**Appendix E. Available Conditional Acceptance
Letters Referenced in the ATTR**

Subject: Conditional Acceptance of Free Chlorine Disinfection at City of Brentwood to comply with California Water Recycling Criteria (0790005-704)

12-lamp 24-lamp 36 lamp
 Figure 1-1. 3D Rendering of the Aquaray® HiCAP Modules

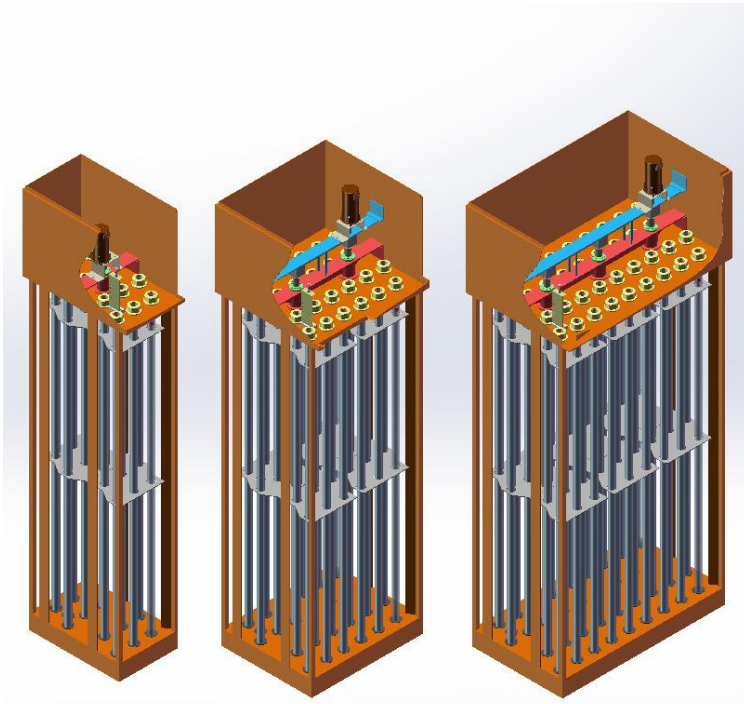
The Aquaray® HiCAP comprises three different module sizes as illustrated in the HDR, Inc., June 2016 report, Figure 1-1, *3D Rendering of the Aquaray® HiCAP Modules*. The modules have twelve, twenty-four, or thirty-six 1000-W low-pressure high-output (LPHO) Amalgam lamps in a staggered array oriented vertical to the flow in an open channel. A mechanical sleeve cleaning system is typically provided. During bioassay testing lamps were turned on and off in half-bank segments, with a half-bank consisting of 2x6-lamp rows across the channel width. Therefore, a bank of Aquaray HiCAP modules consists of 2 half-banks or 4 rows of lamps with 2 rows per half-bank. As shown in the validation report, Figure 1-2 *Various Lamps Groups for the Adjacent 12-lamp Modules Configuration* and Figure 1-3 *Various Lamps Groups for the Single 24-lamp Modules Configuration* illustrate how the lamps inside the test channel were grouped per banks, half-banks and rows for either the two adjacent 12-lamp modules or the single 24-lamp modules, respectively.
